## **MEMORANDUM**

**SUBJECT:** Committee of Adjustment Variance Application

339 Main Street North, Markham Village

A/146/22

**Appendix 'D'**Architectural Drawings

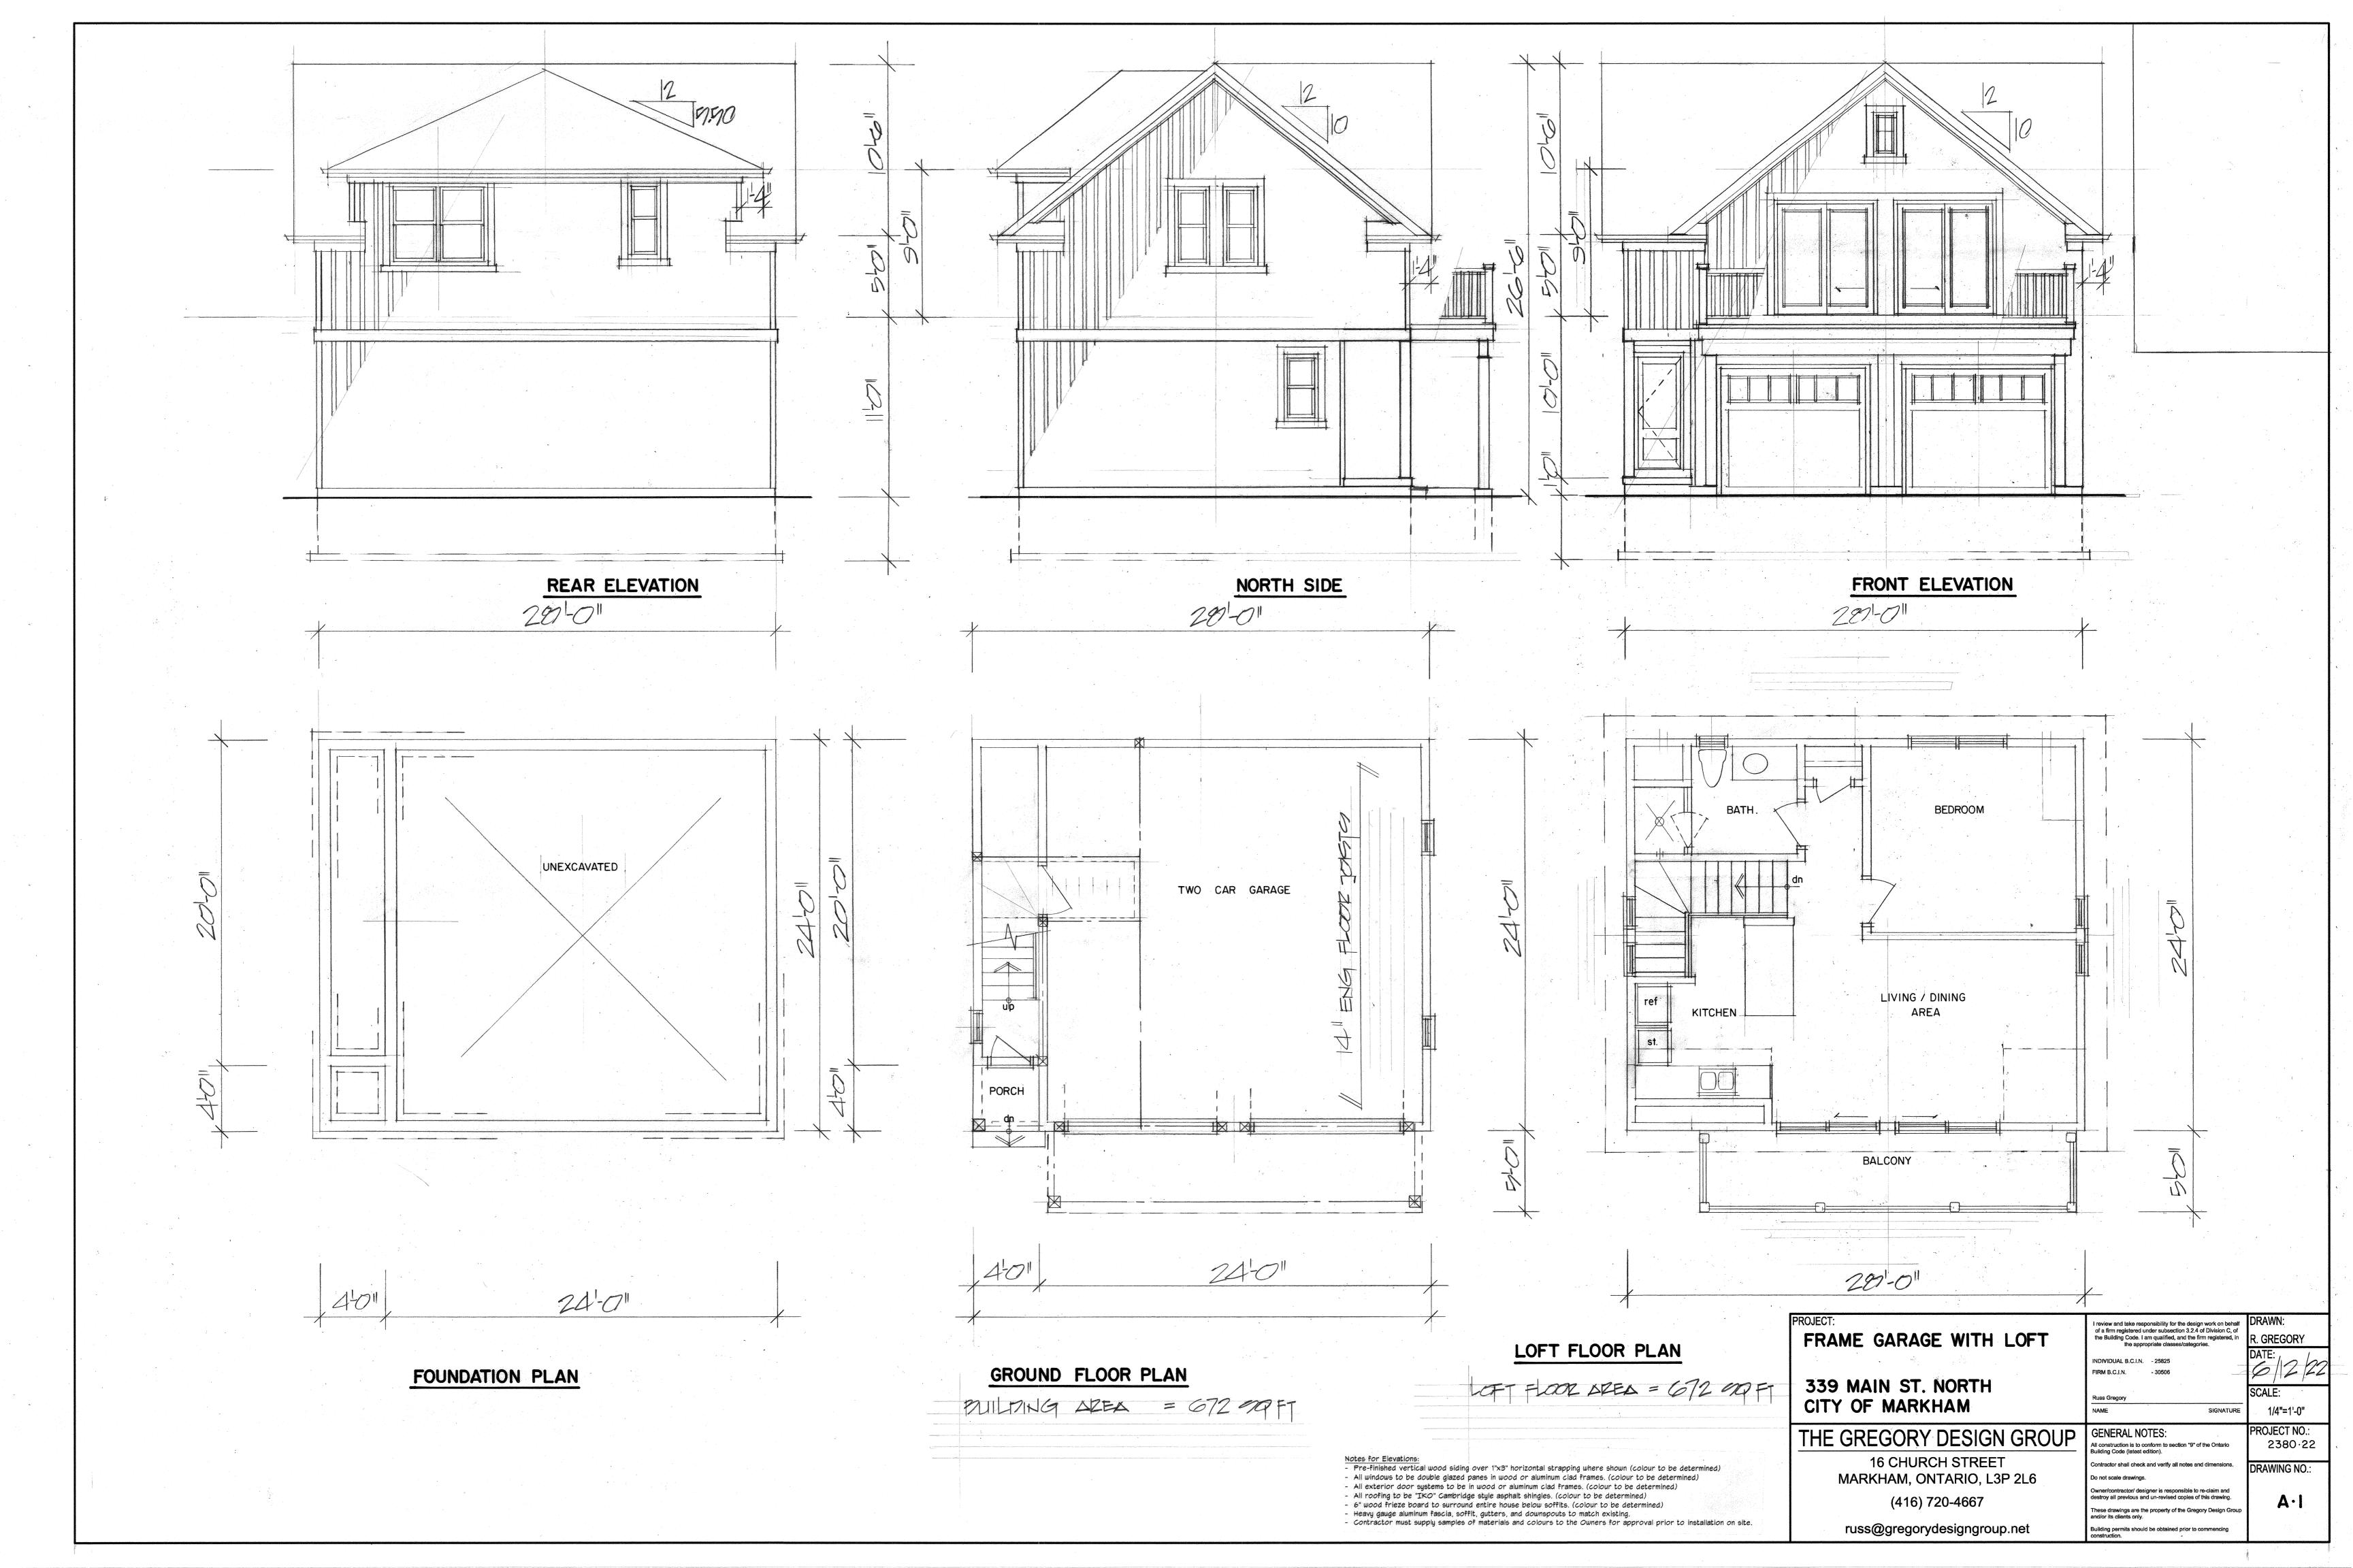
- Urban Design (UD) staff have identified overlook and privacy as an area of concern. UD staff recommend an increased setback (minimum 3.0m) between the proposed *coach house* and the eastern property line to accommodate the installation of vegetative screening and a privacy fence adjacent to the townhouse complex. UD staff will also work with the applicant on window configuration on the north and rear (east) elevations of the *coach house* to ensure adequate daylighting while providing privacy for neighbouring properties.

- It is also suggested that the applicant substitute the proposed sliding glass door along the west elevation with a door that is more traditional in configuration;
